T10: T10 Technical Committee (SCSI)

From: Charles Binford, Sun Microsystems, Inc., (charles.binford@sun.com)

Subject: Target Multiport Model

Figure X

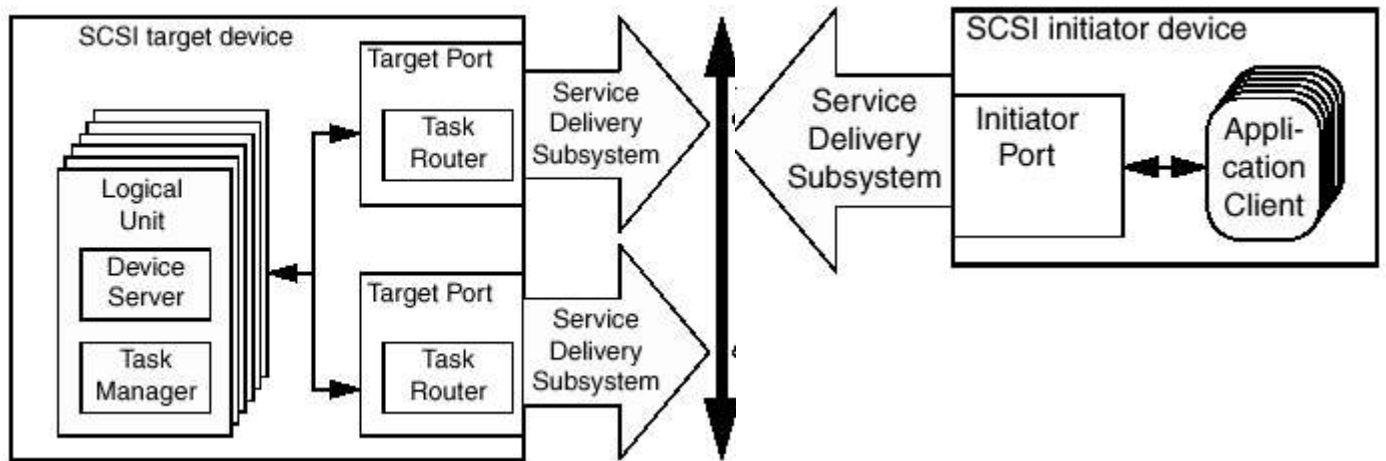
The key question this figure will answer is how many “initiators” does the target see? Should the target differentiate this from figure 21 above?

This subject came up at January's CAP meeting and it quickly became clear that there were different opinions/interpretations of how this configuration is viewed per SAM. Some felt that given the current transports defined for SCSI, that the target can and should figure out that the SCSI Initiator Port Name is the same at treat IOs delivered via either target port as if they were from the same SCSI initiator port.

Others (at least me! :-)) feel that should SAM require the target to treat this configuration as if there were two separate initiators.

For a redundant array controller configuration, having a device server view Figure X as two separate initiator ports allows for a much looser coupling of the task sets when TST=001b or Qerr=11b.
